**Proposed Amendments to the Jersey Avenue Park Redevelopment Plan
Emerson District**

February 1, 2017

Jersey Avenue Park Redevelopment Plan Land Use District Map

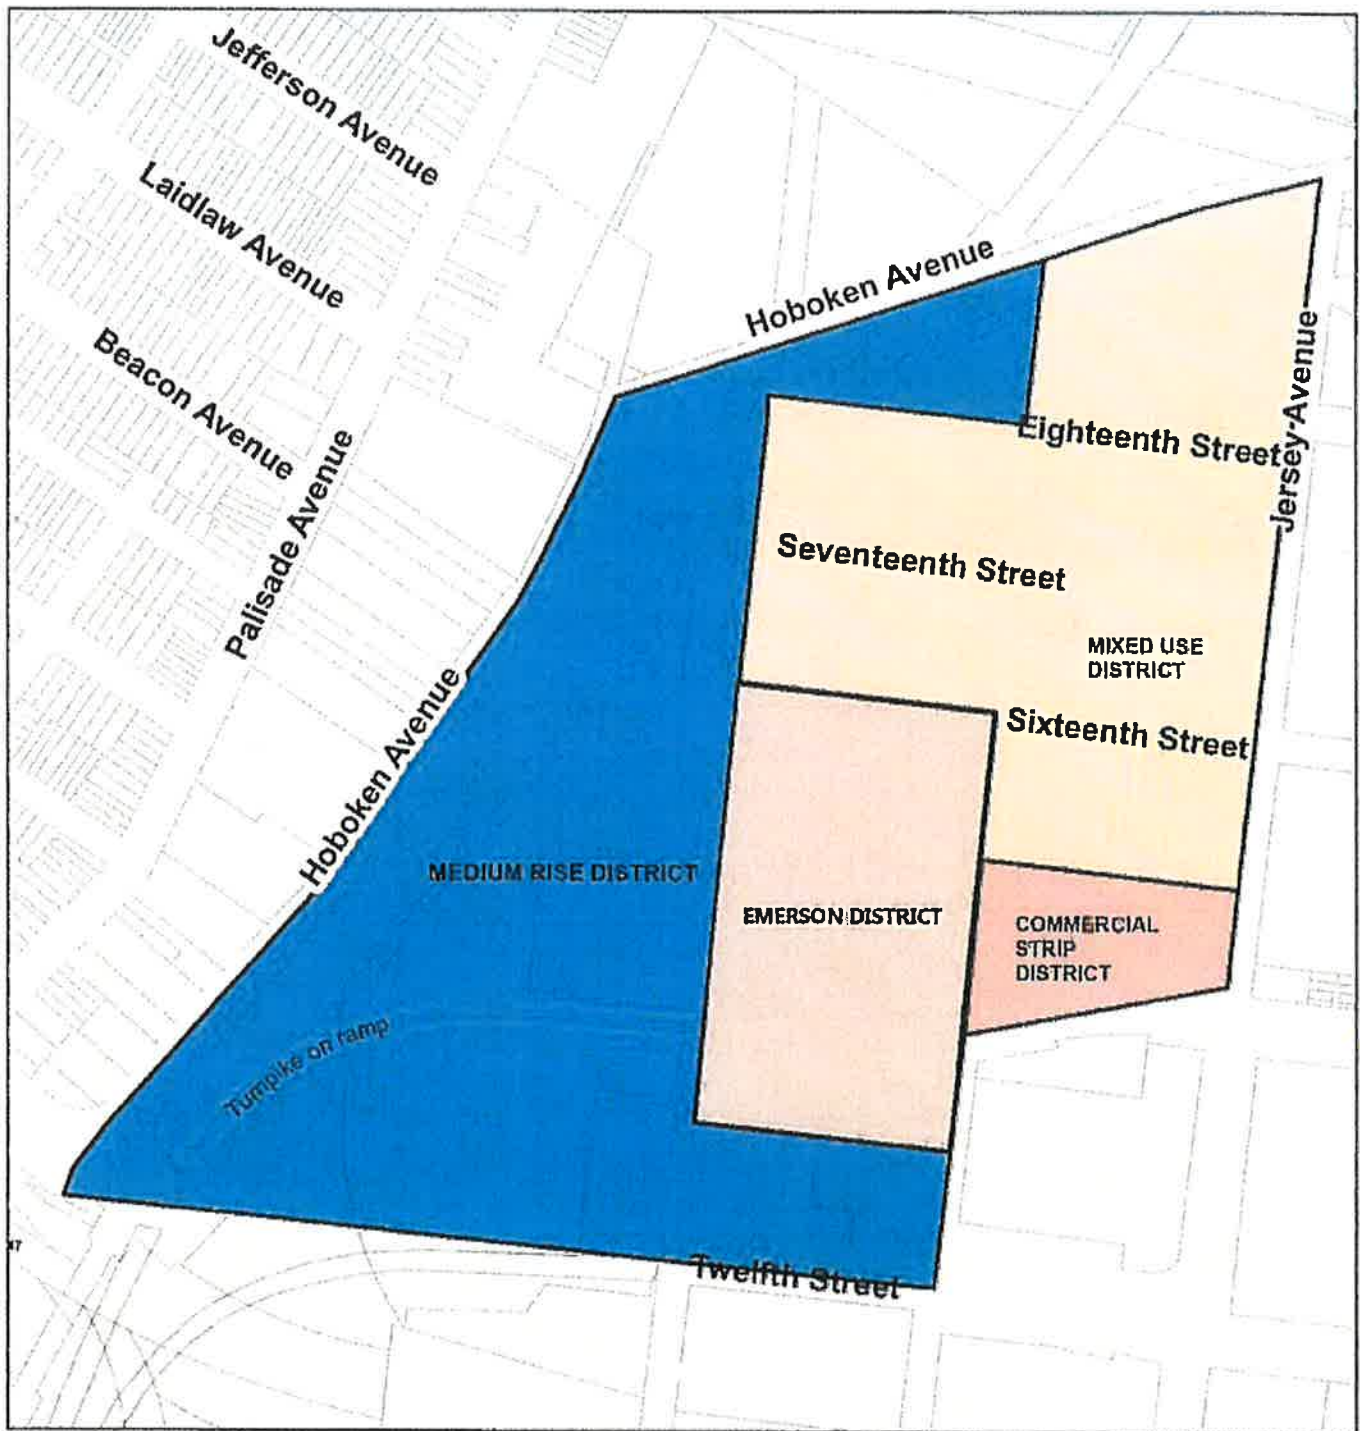
The boundary of the Jersey Avenue Park Redevelopment Area is presented on ~~the Redevelopment Area~~ ***Boundary Land Use District*** Map. The boundary of the Redevelopment Area can generally be described as beginning at the intersection of the centerlines of Hoboken Avenue and Jersey Avenue to the north and continuing south along Jersey Avenue to 14th Street, thence turning southwest along 14th Street to the centerline of Coles Street, thence turning south along Coles to the centerline of 12th Street, thence heading west along the centerline of 12th Street to the centerline of Hoboken Avenue, thence following the centerline of Hoboken Avenue to the north and turning east until reaching the beginning point at the centerline of Jersey Avenue.

- Development regulations for the Redevelopment Plan Area consist of two interrelated parts, land use district regulations and the Land Use District Map. The land use districts are designated as the Medium Rise District, the Mixed Use District, *the Emerson District* and the Commercial Strip District. The area at Monmouth Street between Seventeenth and Fourteenth Streets has been dedicated solely to the Newport Electrical Substation. Uses in this area shall be necessary or ancillary to the Electrical Substation function, and shall be reviewed and approved by the Planning Board. *Land within the substation area may also be utilized to re-open Monmouth Street to a 60-70 foot right-of-way width.*

Jersey Avenue Park Redevelopment Plan Emerson District Max. Permitted Heights Map

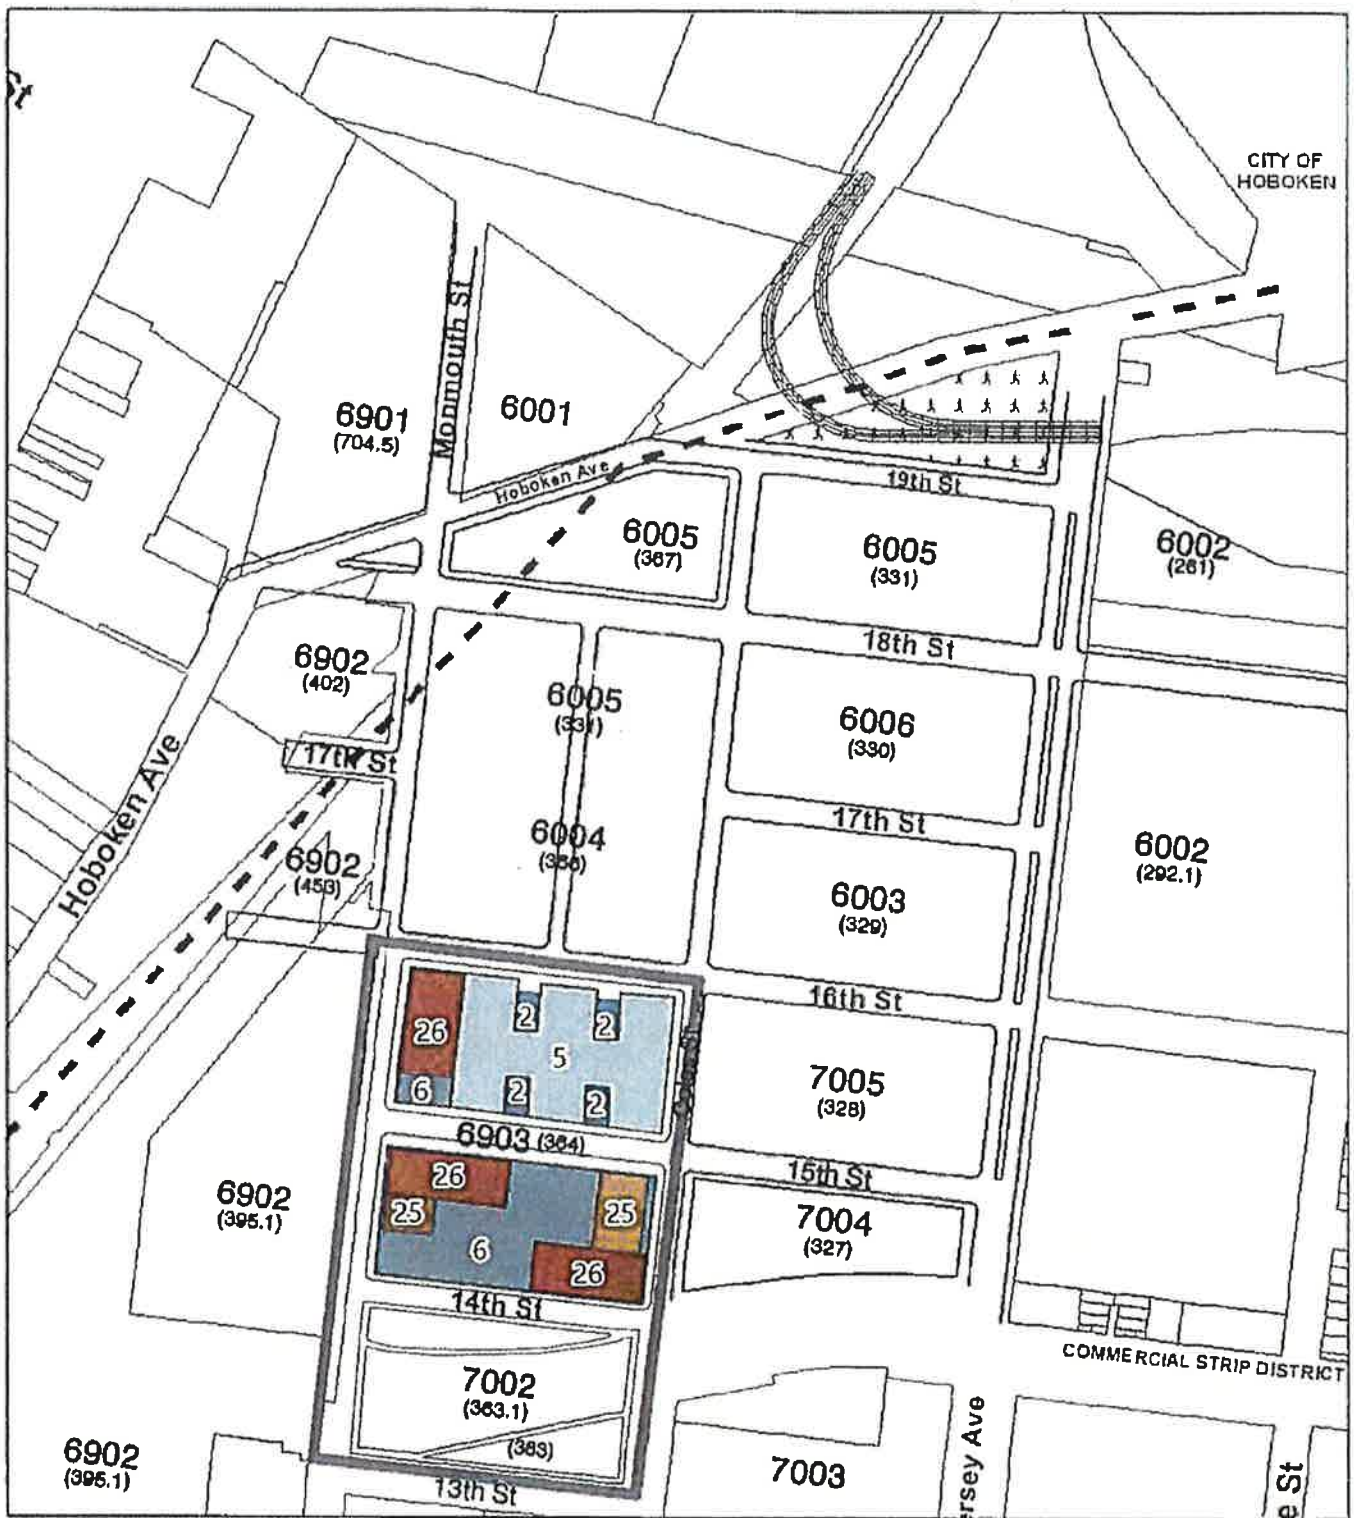
- a. Building heights within this zone shall be as indicated on the proposed height map for the Emerson District and paragraph 8 and 9 of this Plan.
- b. That portion of the former Emerson Building to be retained and indicated on the Adaptive Reuse and Demolition Plan Map shall remain as a 5-story

Jersey Avenue Park Redevelopment Plan Emerson District Ground Floor Frontage Map

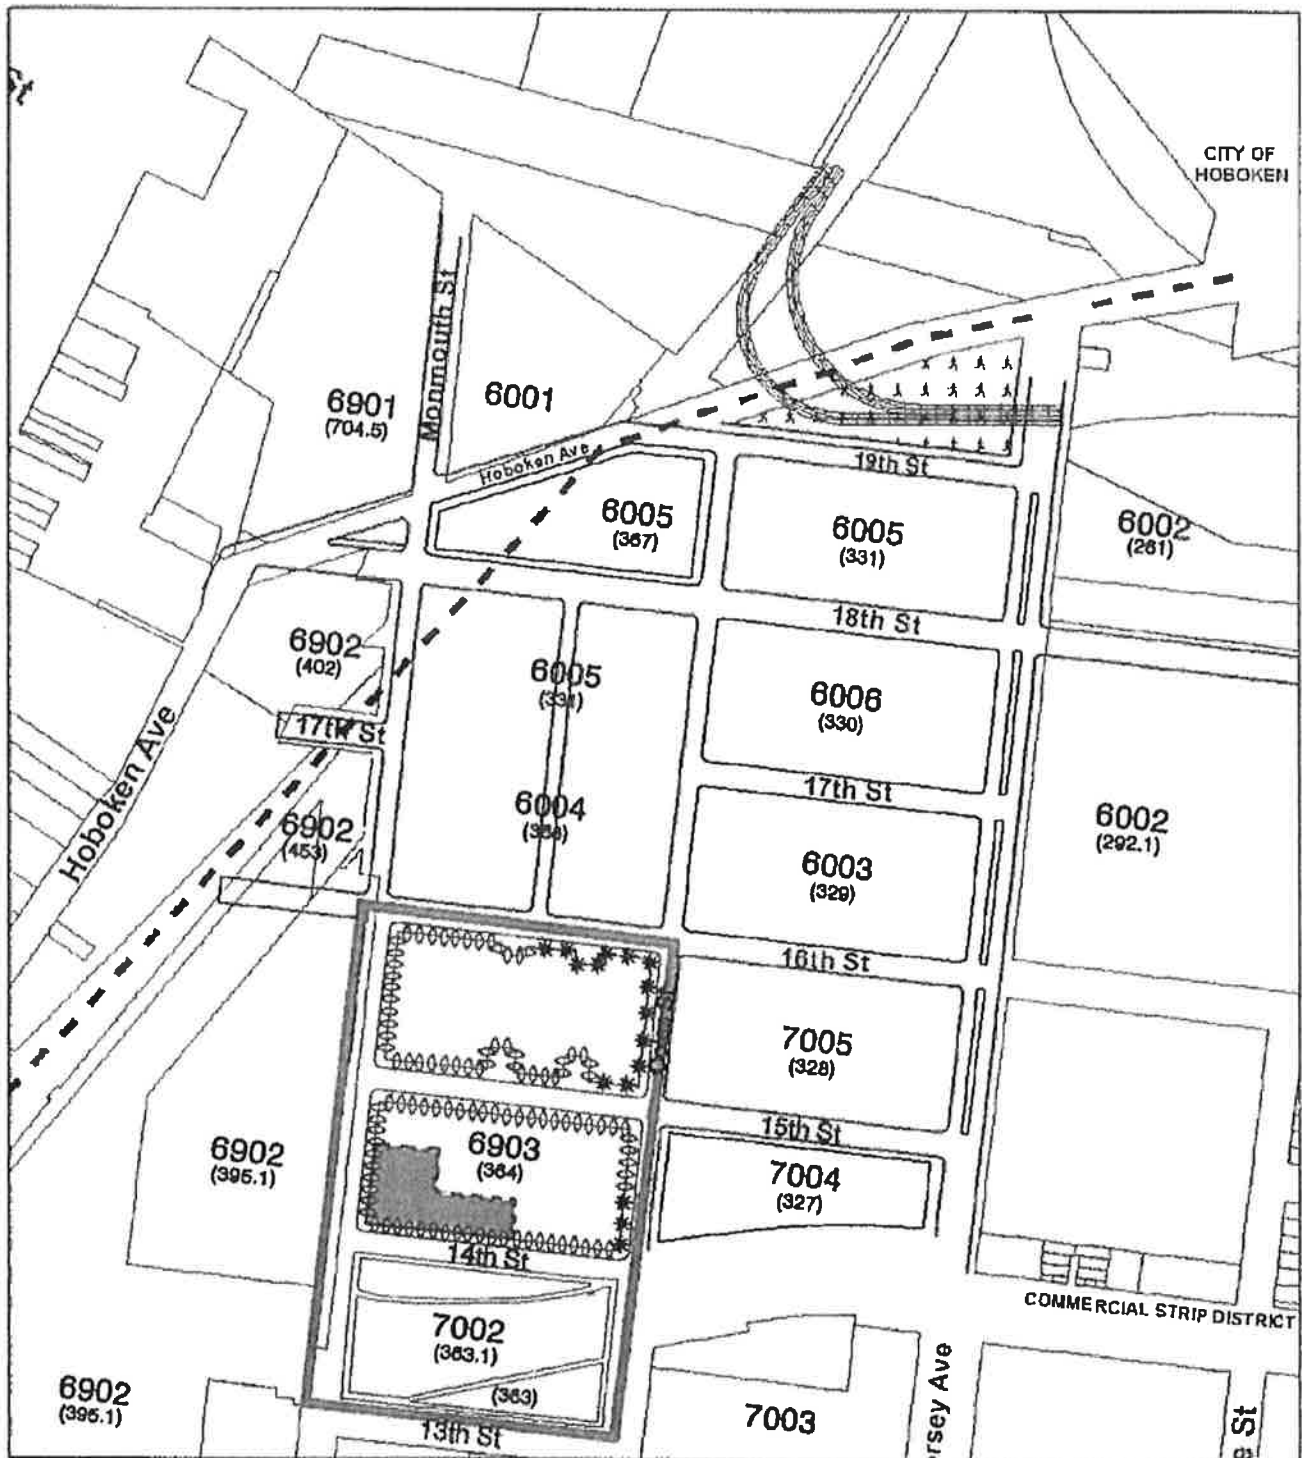
4. Permitted Uses: Please also refer to the Ground Floor Frontage Map for the location of Required Retail Frontages and other ground floor uses. The permitted uses in areas indicated as Retail required shall be commercial uses that serve to activate the building frontages and streetscape such as Retail Sales of Goods and Services, Restaurants, Bars and Night Clubs, and other similar uses.

Jersey Avenue Park Redevelopment Plan Emerson District Adaptive Reuse and Demolition Map

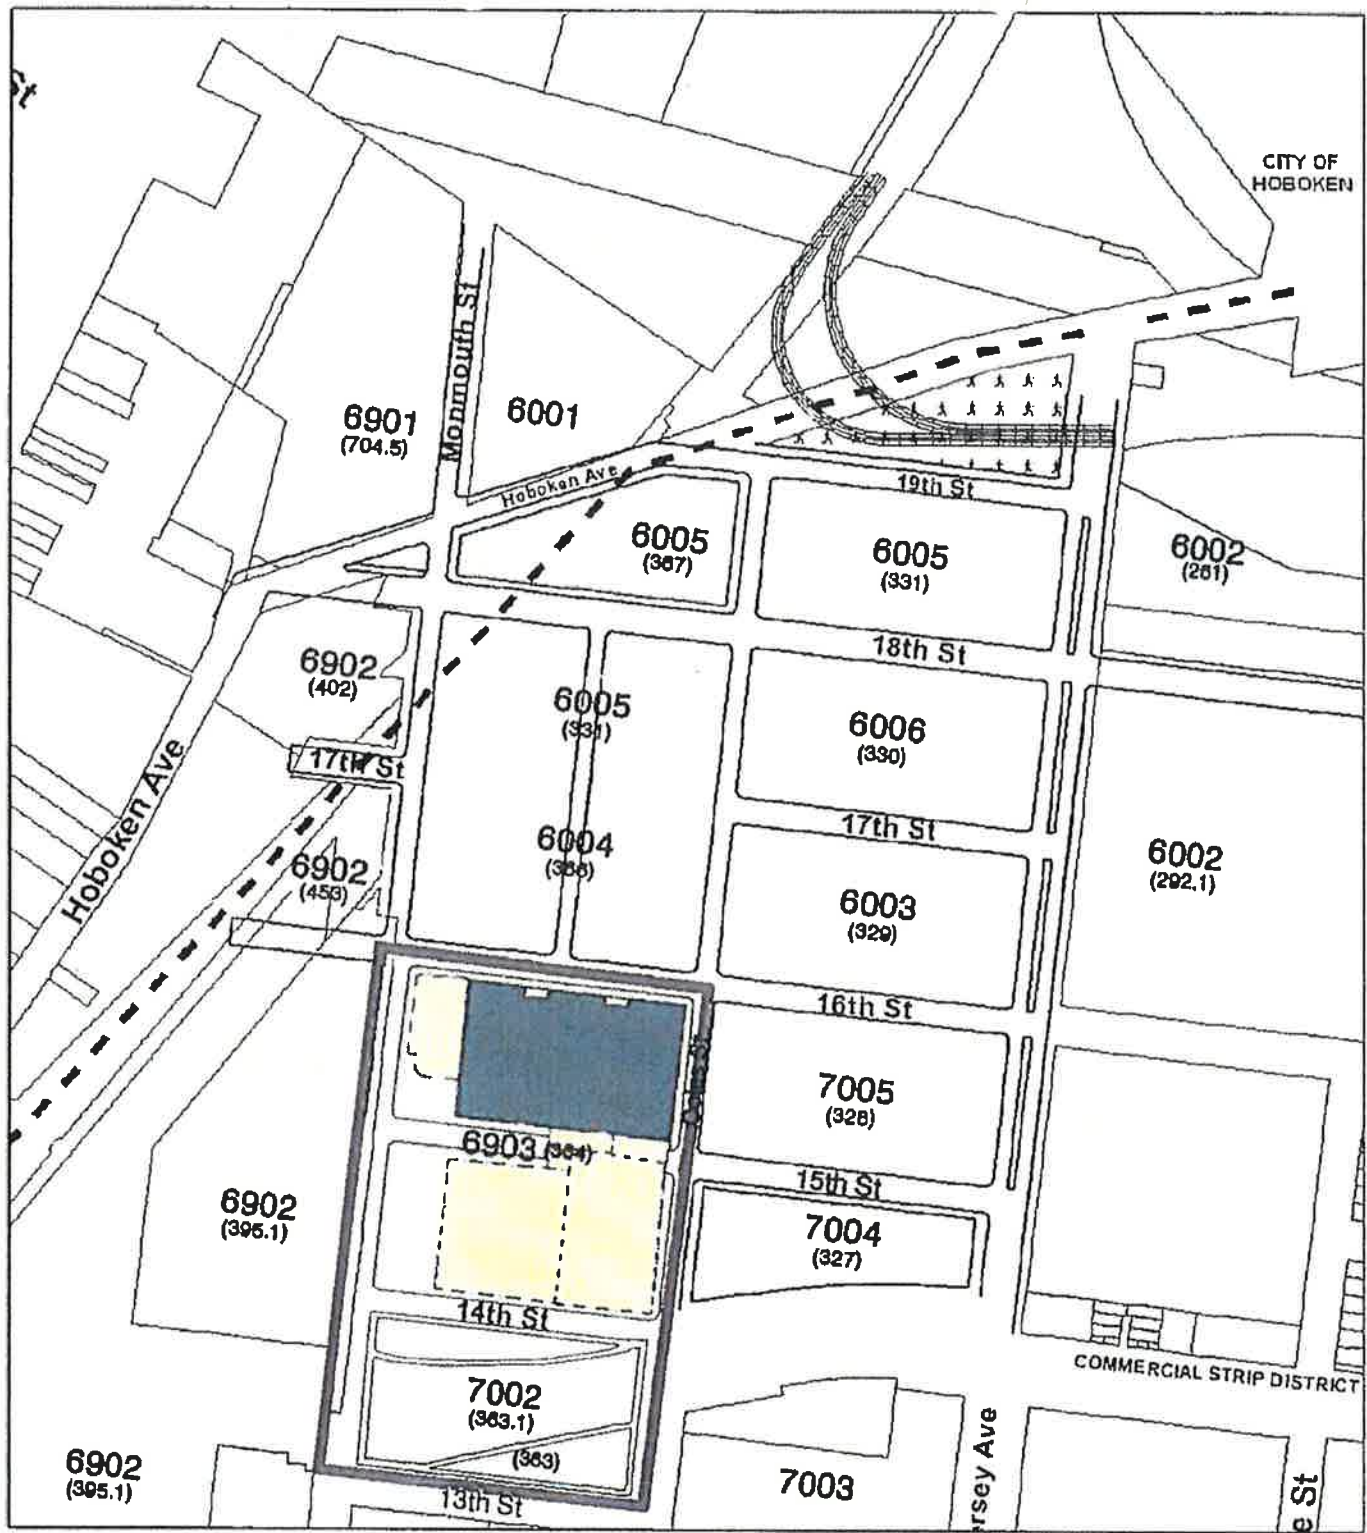
- a. That portion of the Emerson Building lying north of the former Fifteenth Street right-of-way shall be retained as indicated on the Adaptive Reuse and Demolition Plan Map for this Zone. Existing architectural features of the building are to be retained and restored. The rehabilitation of the northern portion of the Emerson Building shall be carried out in a manner that respects the industrial character of the existing building utilizing in-kind materials and finishes. Care shall be taken in selecting replacement windows, doors, and other materials in order to maintain the architectural style and industrial character of the structure. Replacement windows shall match the original size and have similar window patterning. Additions to the existing building, such as rooftop bulkheads and amenity space, and new buildings adjacent to the existing structure, may be done in a

Jersey Avenue Park Redevelopment Plan Circulation, Bikeways, and Open Space Map

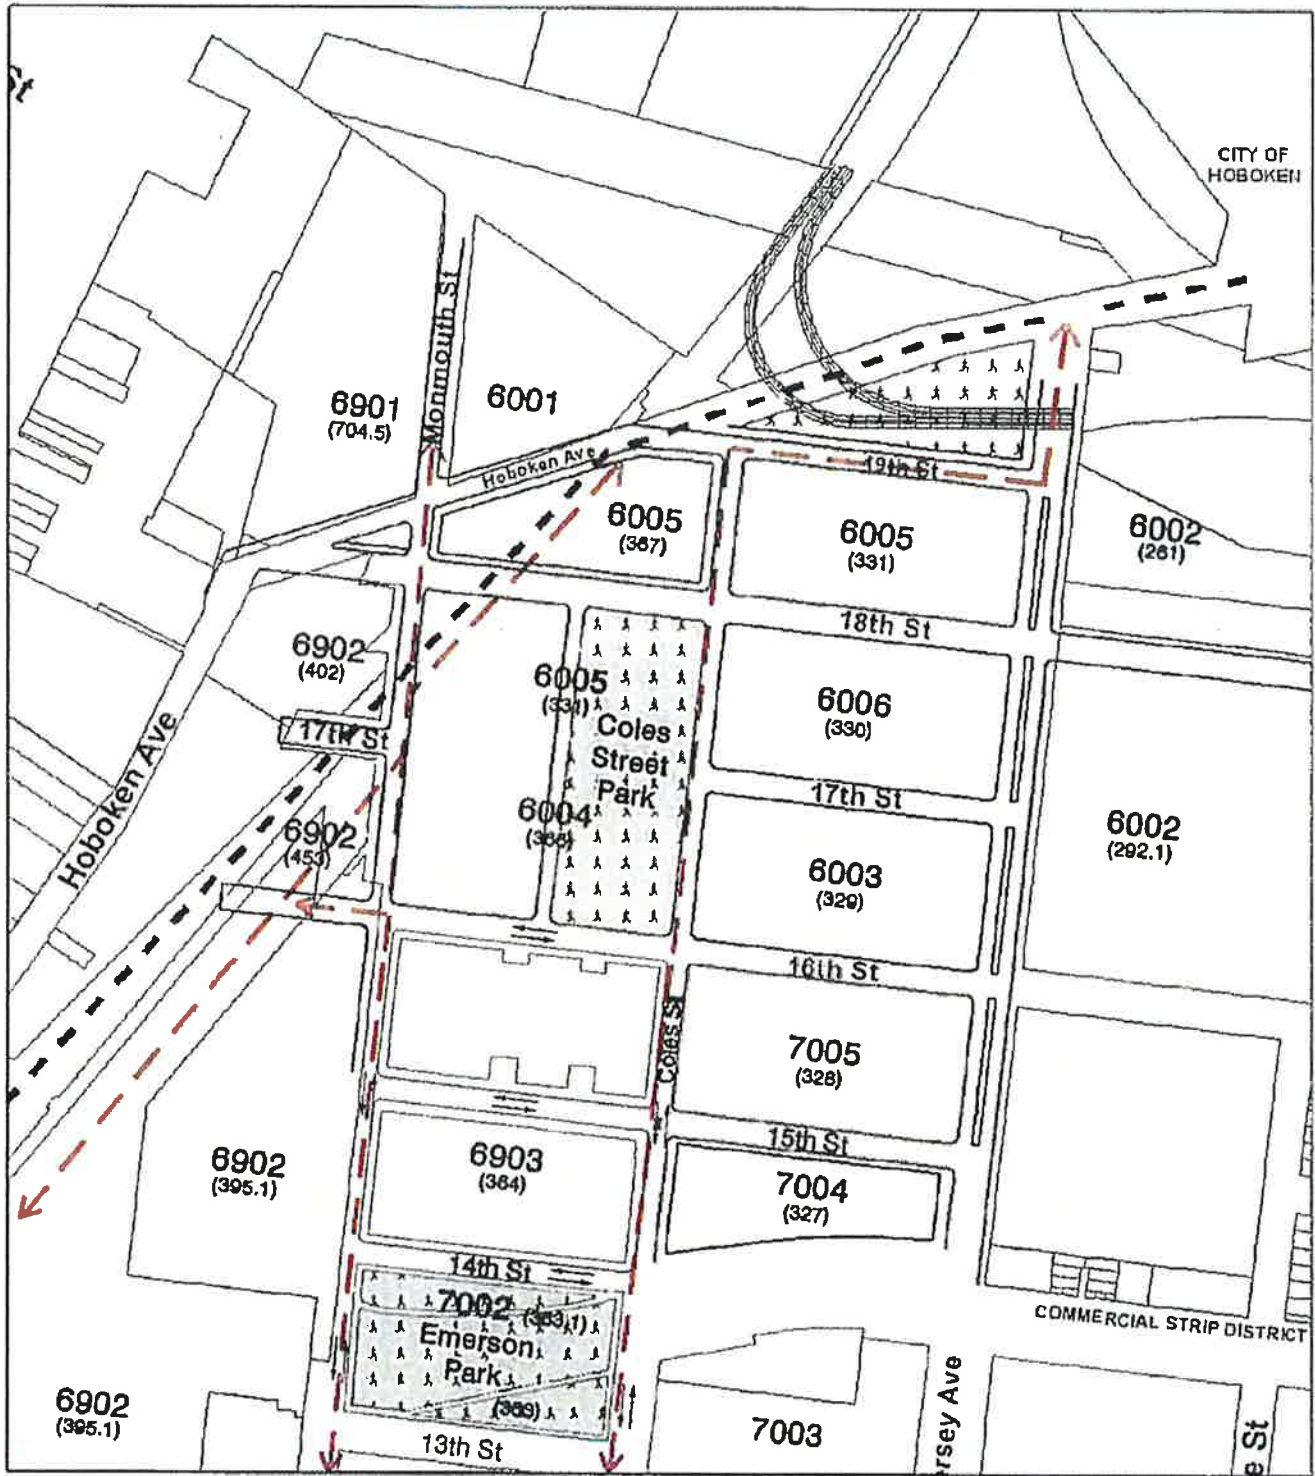
11. The construction of bikeways and public open spaces including the Coles Street Park as depicted on the Circulation, Bikeways and Open Space Map included within this Redevelopment Plan, at such time when the land required to construct the Coles Street Park has been dedicated, conveyed, and accepted by the City of Jersey City; and the Emerson Park as depicted on the Circulation, Bikeways

and Open Space Map included within this Redevelopment Plan at such time when the land required to construct the Emerson Park is no longer being used for its current use. Open spaces within the area shall be designed to introduce a range of functional, passive and recreational elements to the District. Pedestrian walkways and bikeways shall be designed to link open spaces, residential, transit, office and retail elements within this and adjoining neighborhoods. Open space shall contain designed landscaping and lawns, play equipment, high architectural materials and finishes for fencing, decorative walls, pedestrian pathways, seating, lighting and other hardscape furnishings. When designing open spaces access entry points shall take into consideration the location of ground floor uses at neighboring structures. The timing, construction and public input for the construction of the improvements outlined above shall be governed by a Developer Agreement negotiated and entered into between the city of Jersey City, the Jersey City Planning Board and any developer within the Plan area after it has obtained a site plan approval from the Jersey City Planning Board. The Developer Agreement shall be in recordable form. Final design of the park improvements shall be determined by the Planning Board. Any developer who constructs improved open space on public lands shall be granted an easement by the city of Jersey City for the purposes of entering onto designated property as conveyed, dedicated and accepted by the city of Jersey City.
